Re: 17 North Lake Road
Site Plan Response Memo

This Memorandum responds to the outstanding Site Plan comments set forth in the Kellard Sessions Consulting, P.C. Memorandum, dated November 5, 2020. Kellard's comments are provided below, with our responses in italics.

SITE AND DEMOLITION PLAN
DIMATTEO RESIDENCE

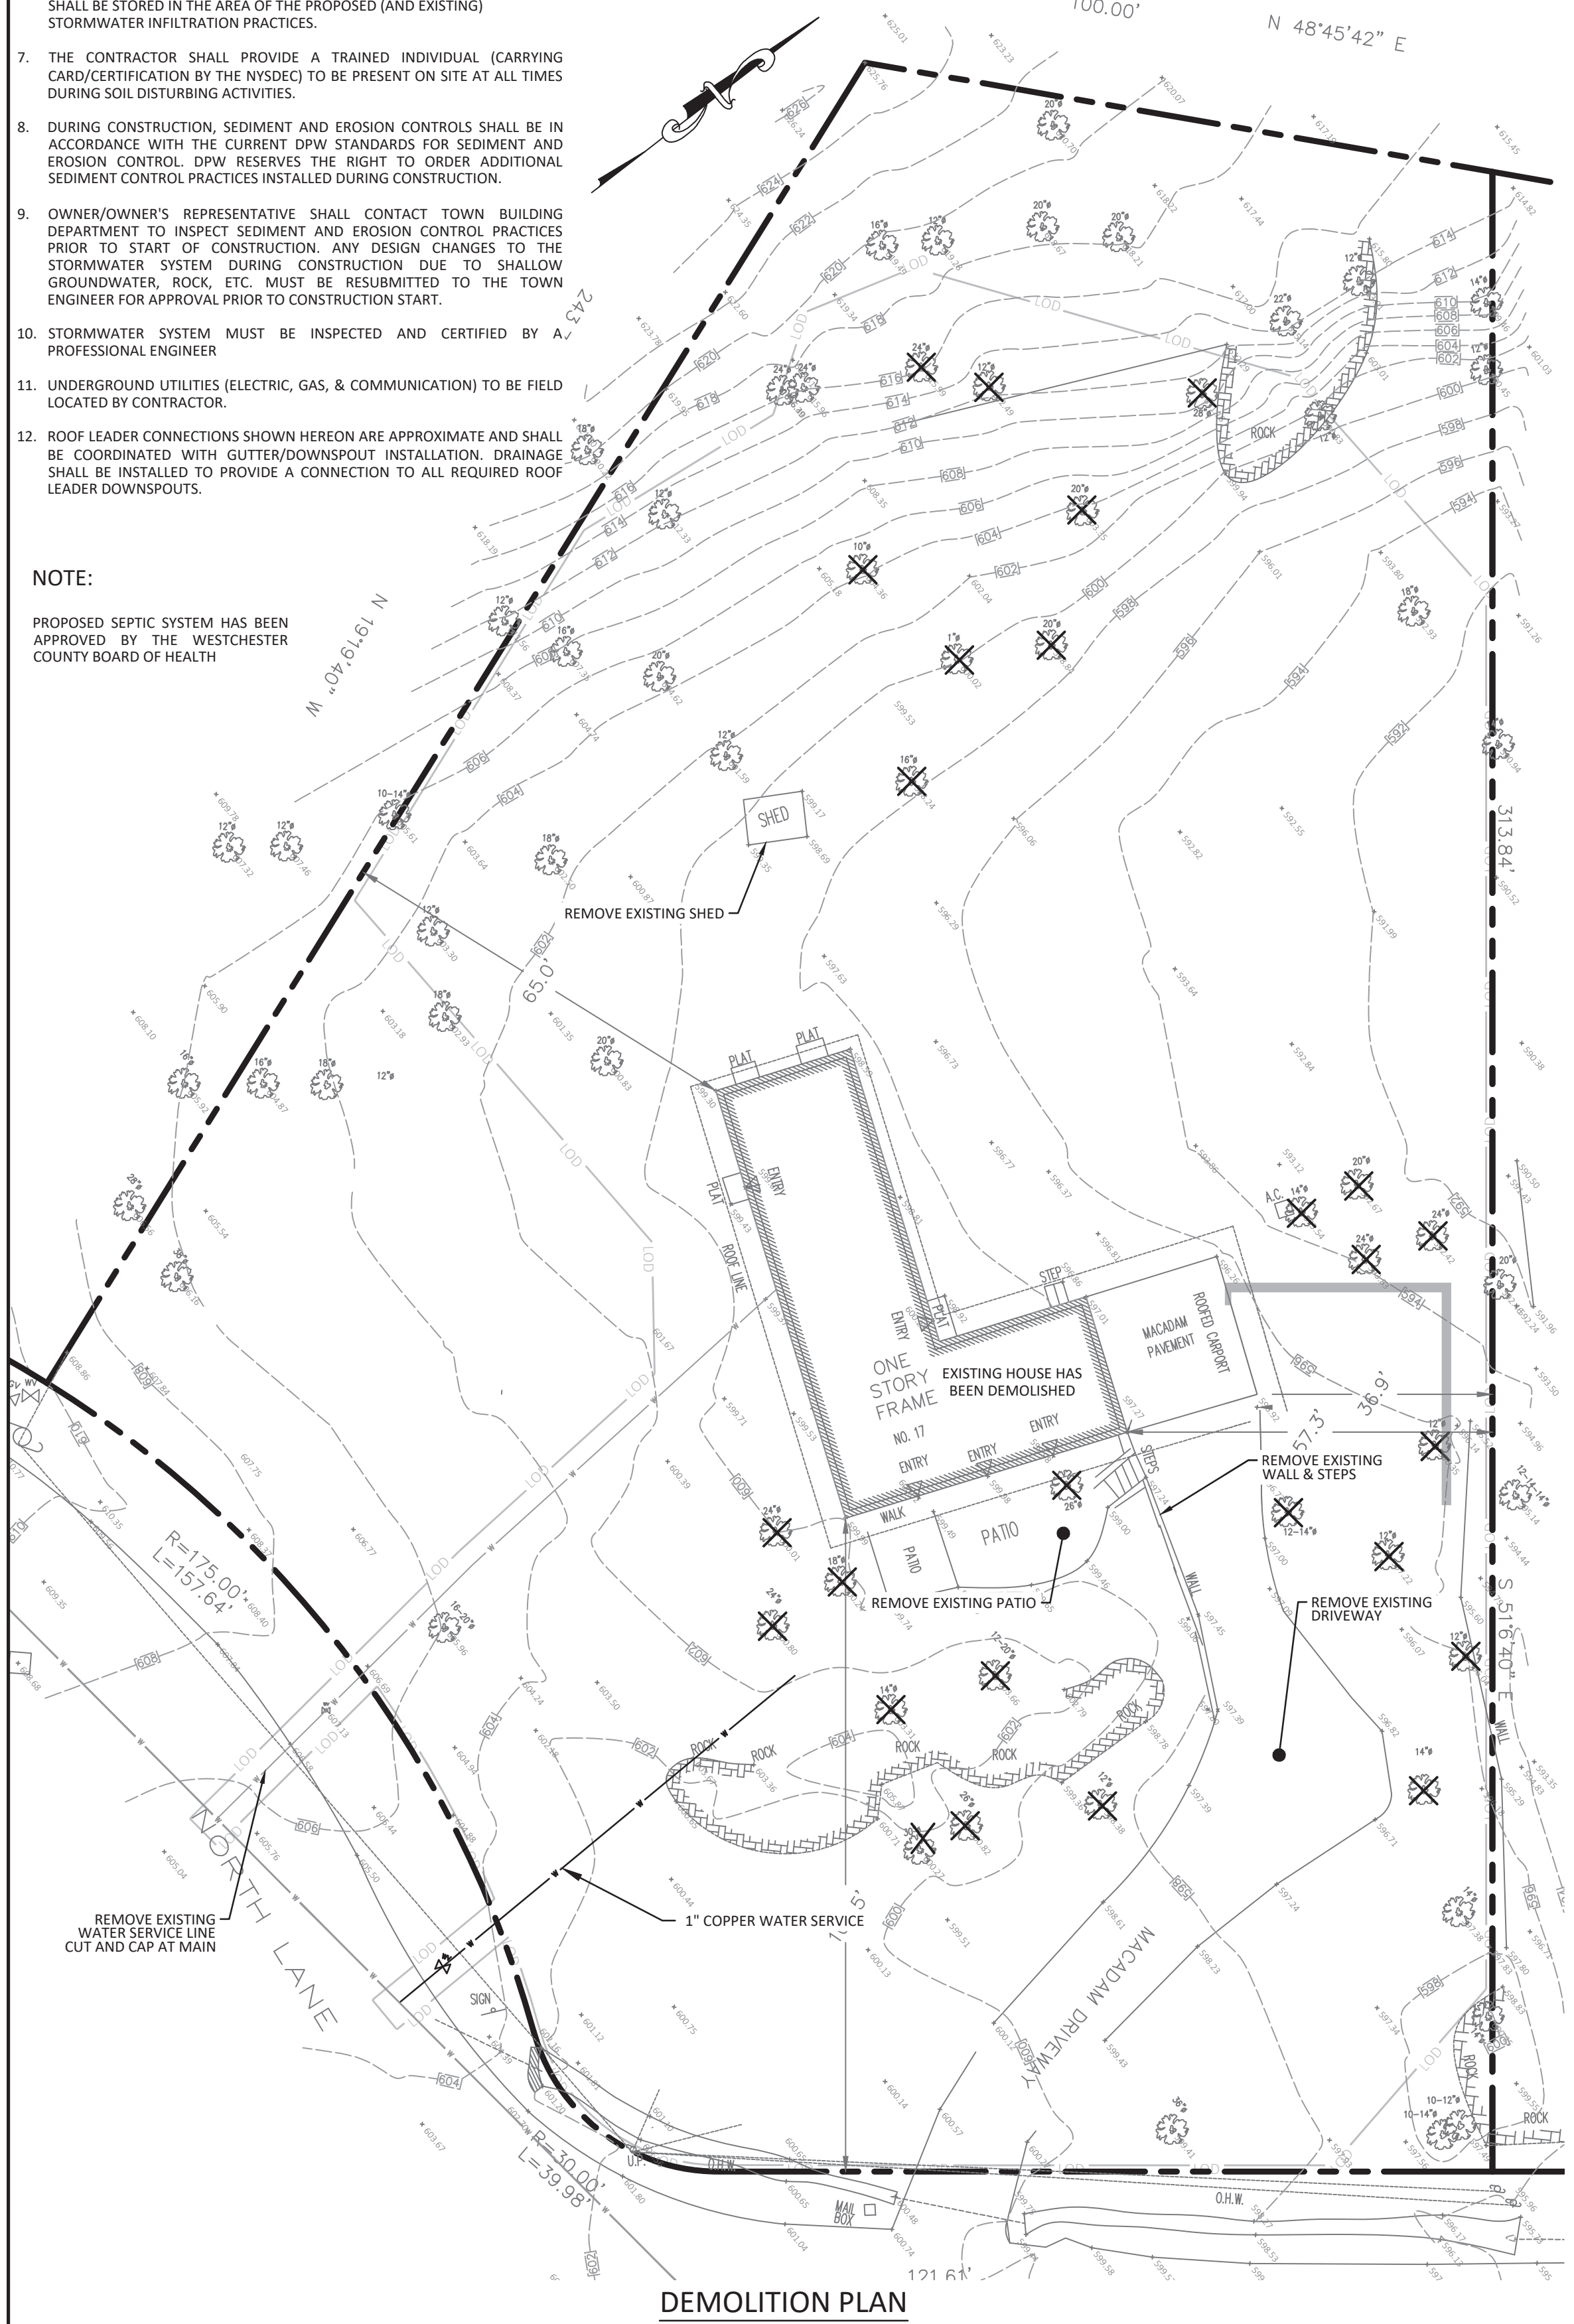
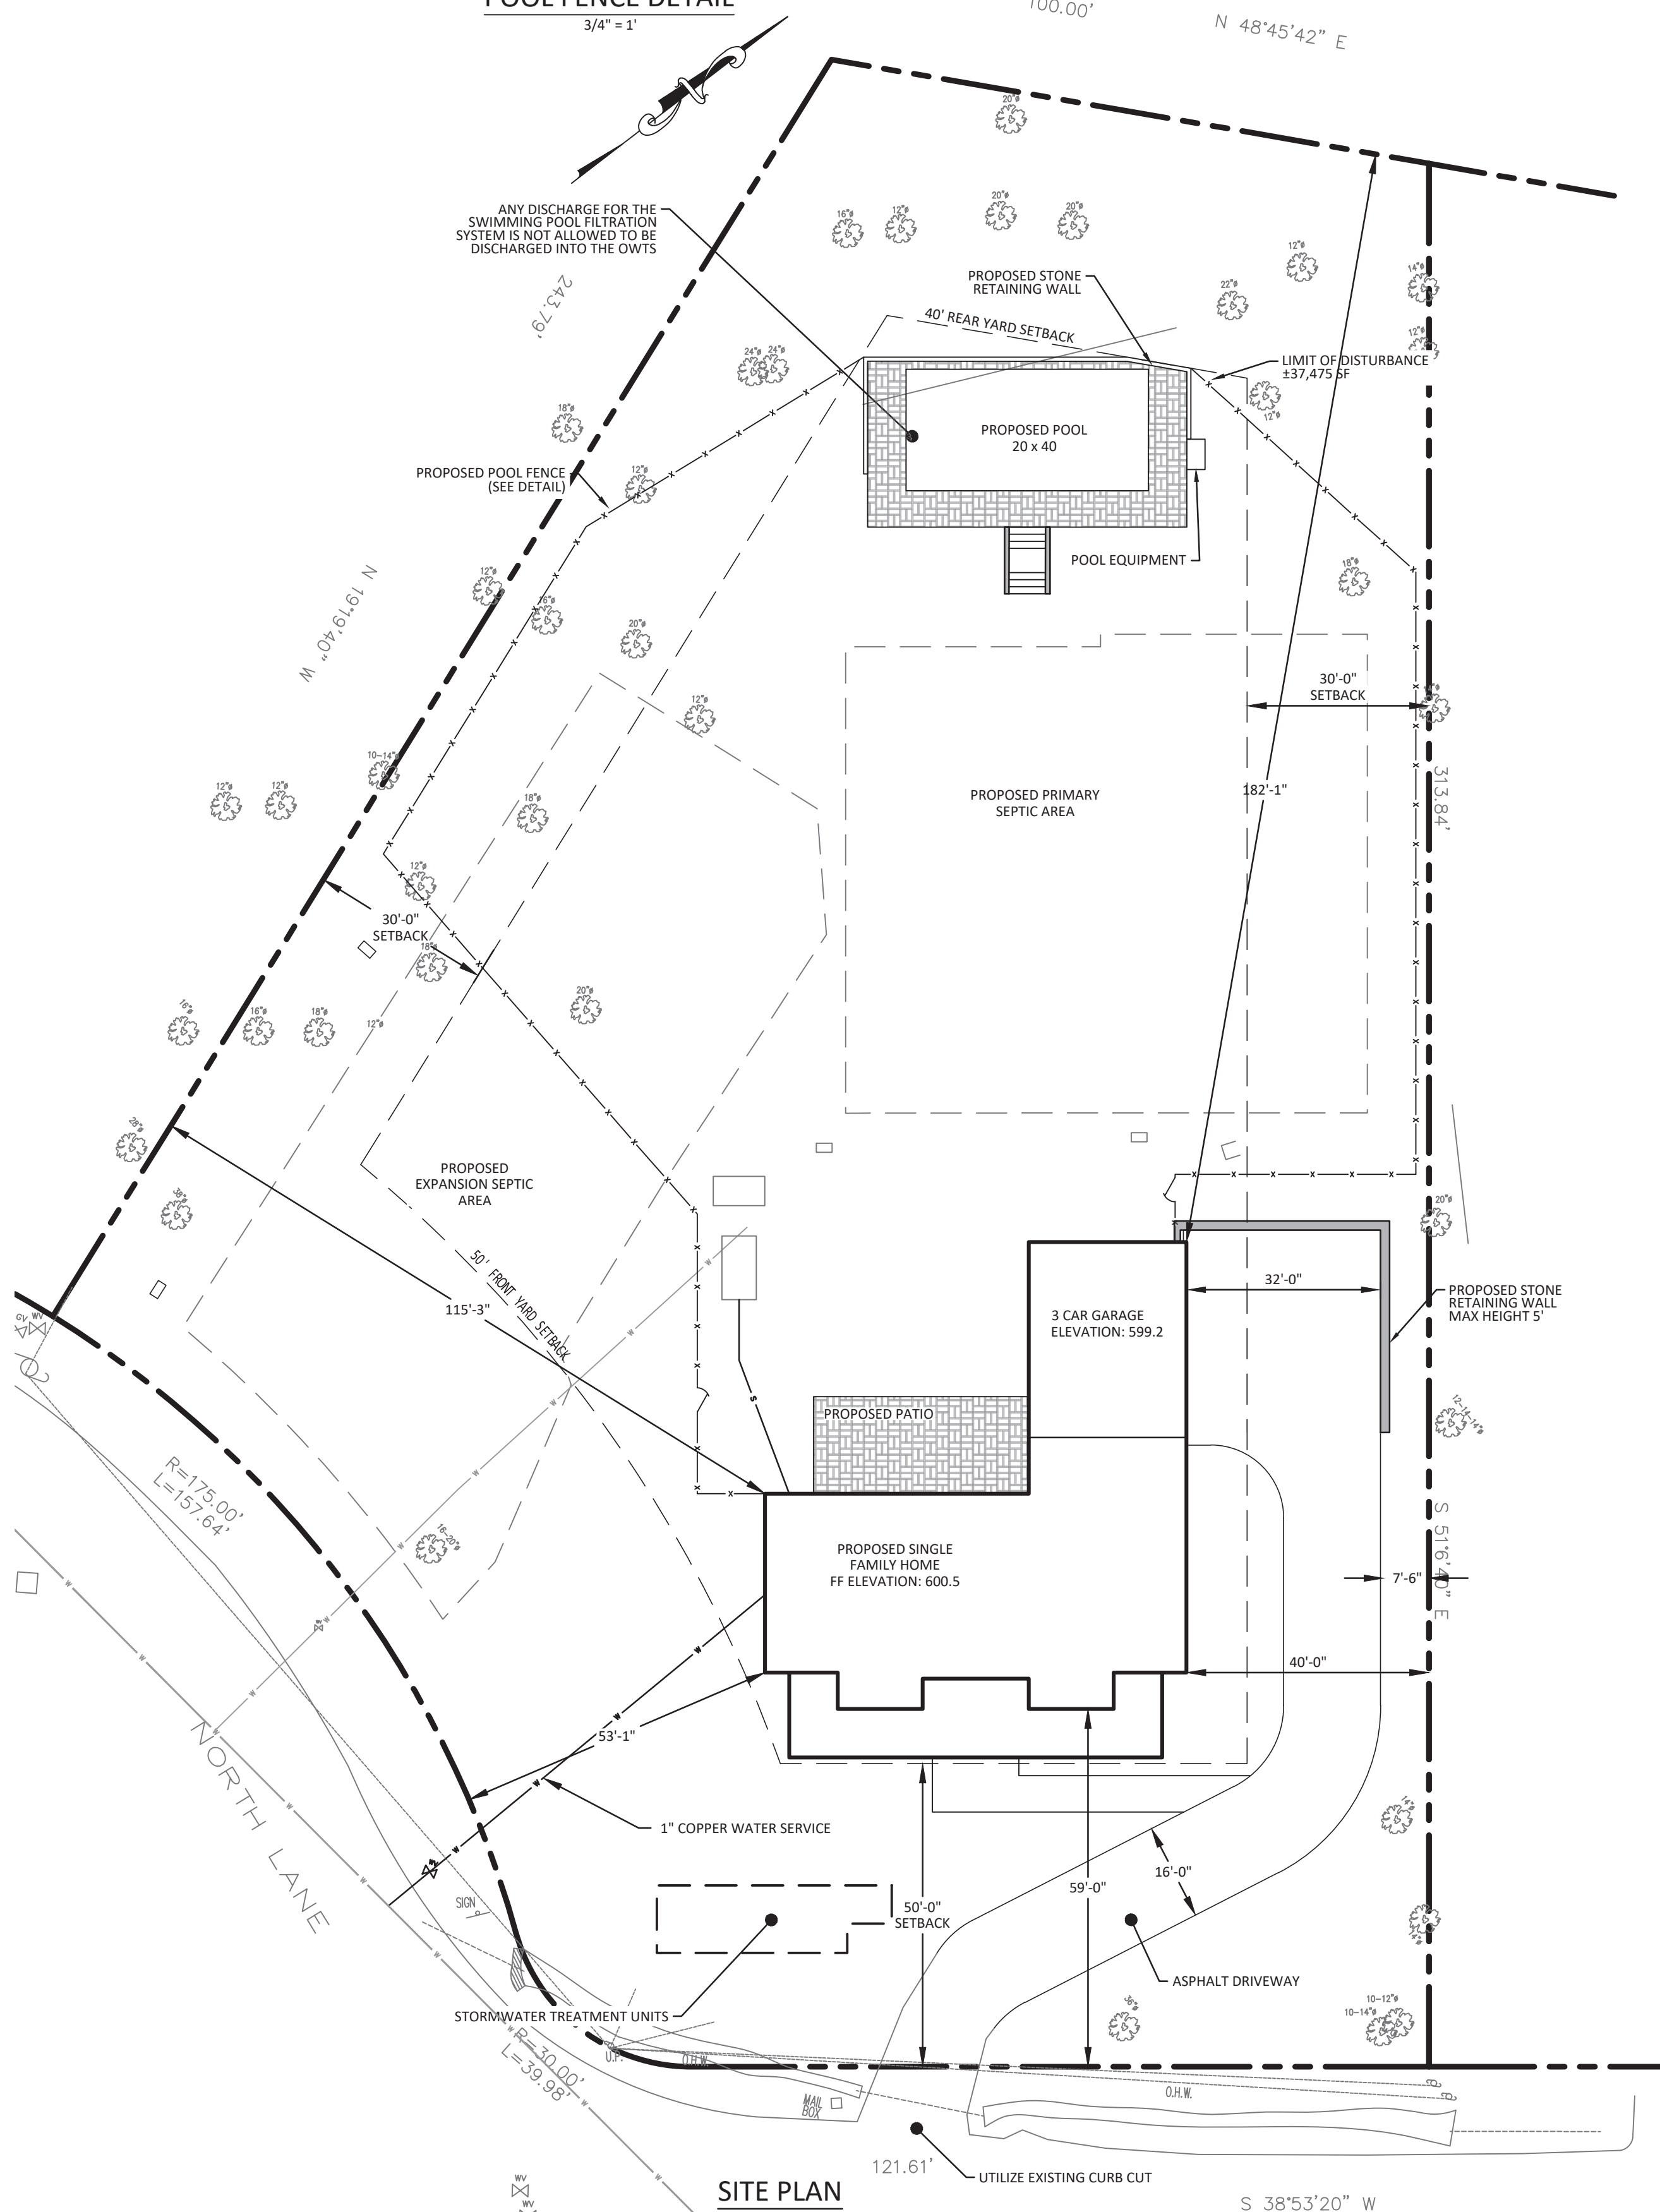
8. The plan illustrates a proposed water service connection to the existing water main in North Lake Road. The plan shall illustrate the location of the existing water service connection and require that it be removed and capped at the main line. The limits of the removals and installation within the road shall be illustrated on the plan and included within the limits of disturbance.

The existing water line is shown to be removed and cut & capped at the line on sheet 1 of the plans. Limit of disturbance has been updated accordingly.
